**From:** [Rael, Rudy E.](#)  
**To:** ["Scott McGee \(scottmmcgee@gmail.com\)"](#)  
**Cc:** [Abiel X. Carrillo](#)  
**Subject:** ABQ School of Excellence  
**Date:** Tuesday, June 28, 2016 1:47:00 PM  
**Attachments:** [image001.gif](#)

Based upon the information provided in your resubmittal received 6/10/16, the above referenced Grading and Drainage plan cannot be approved for Building Permit until the following comments are addressed:

ALBUQUERQUE SCHOOL OF EXCELLENCE

## GRADING AND DRAINAGE PLAN

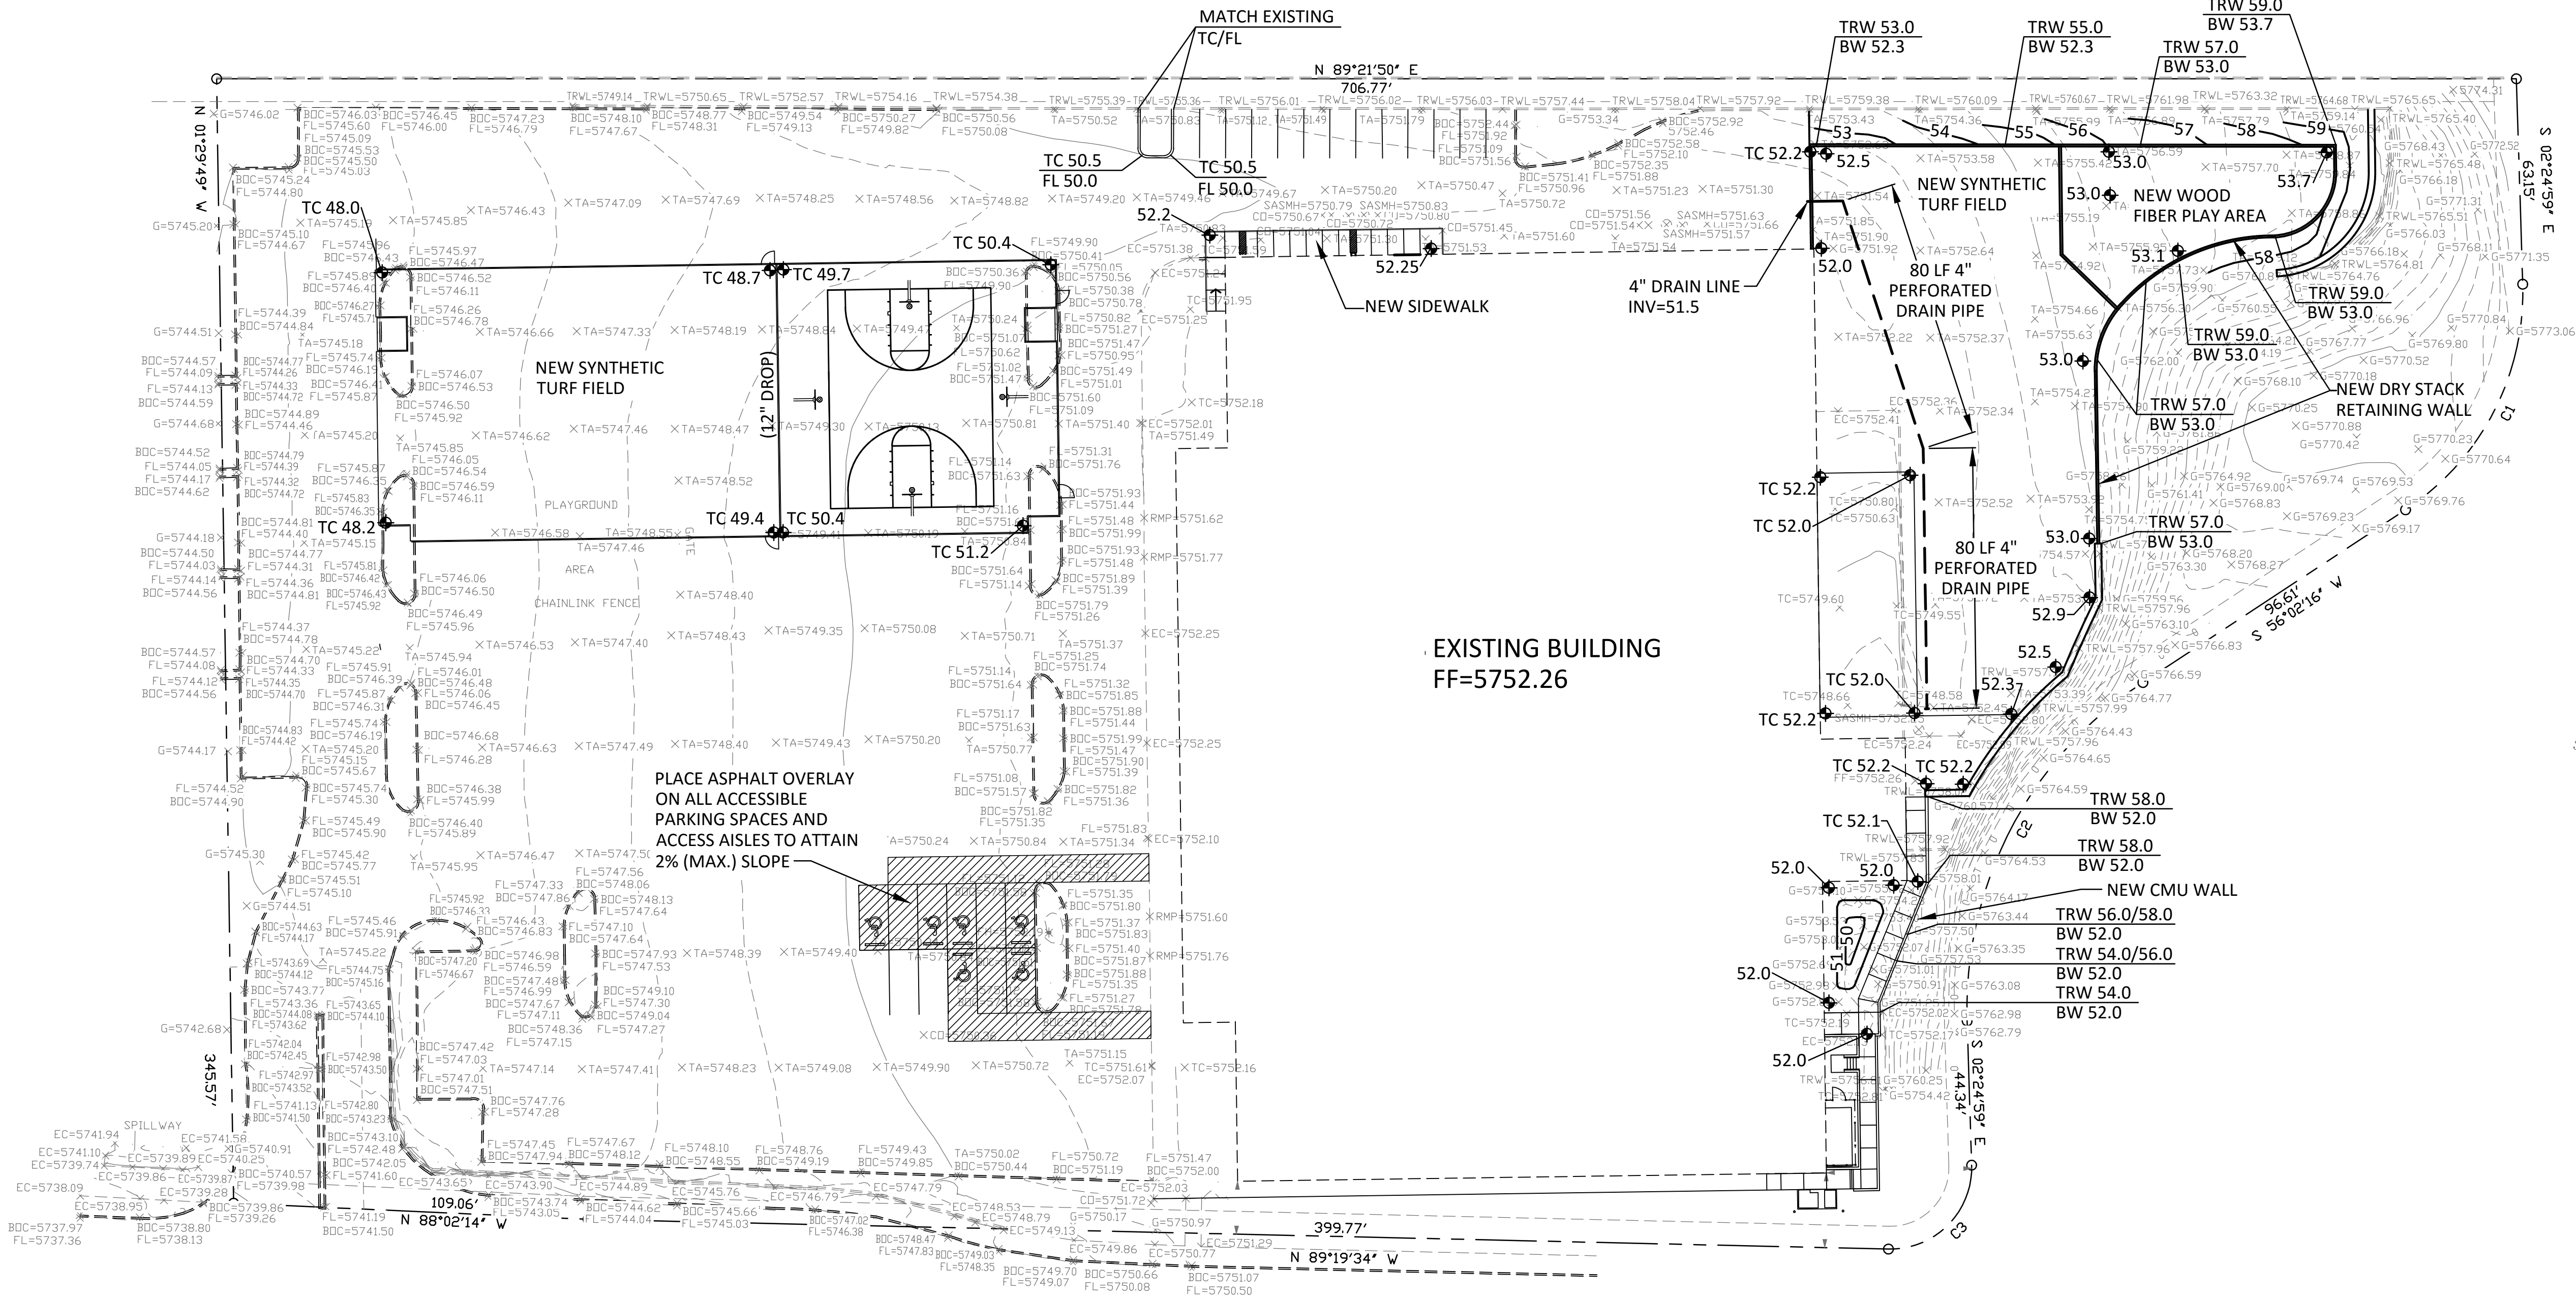
- Provide a detail for the 4" perforated pipe. Show how it will be kept from clogging.
- Show the pond the plan. Provide inlets and outlets.
- If the pond is being used for the First Flush, it must be cleaned, free of weeds and what not.
- Is it possible to provide curb openings in the landscape Islands for first flush ponding?
- Label the double line on the east side of the building. What is it, wall, curb, etc.?
